**DATE:** 07.31.2017  
**TO:** ProTrak  
**FROM:** Bill McDow  
 Transportation Planning

■ **NHRMC WOUND CARE PARKING LOT [TRC Plan Review]**

↻ Initial Review Note ↻

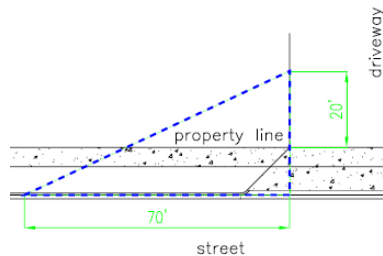
1. Traffic Engineering’s stance on sites that interconnect along a major thoroughfare is that the combined frontage must meet all driveway spacing requirements per the City’s technical standards.
2. When the lot has sufficient frontage, driveways for corner lots along major thoroughfares must have corner clearance of 230’ as measured along the curb line. This site has access to a second driveway along S. 17<sup>th</sup> Street, therefore, this driveway may be required to be closed.
